SMEI DHU Software Patch 34

Commanding Changes

Issue 1

17 November 2004

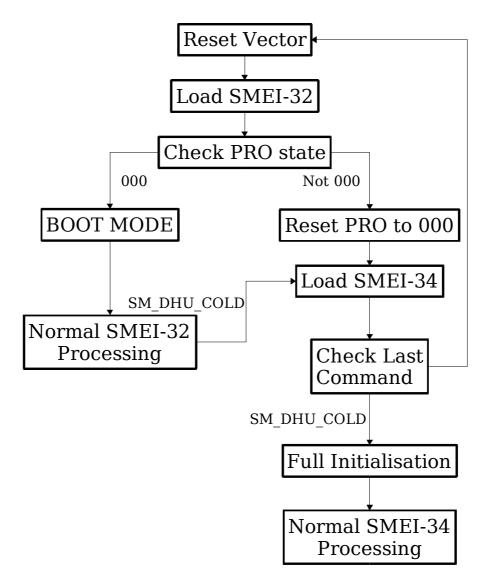
2x2 mode, 3-bit binary flat-field

The additional 2.0 gain factor is compensated for in the flat field table itself.

The Cx_FF_SCALE field of the dynamic configuration must be set to 65535 to provide the full range of output (0.0, 1.0, 1.3, 2.0 and 4.0 gain factors).
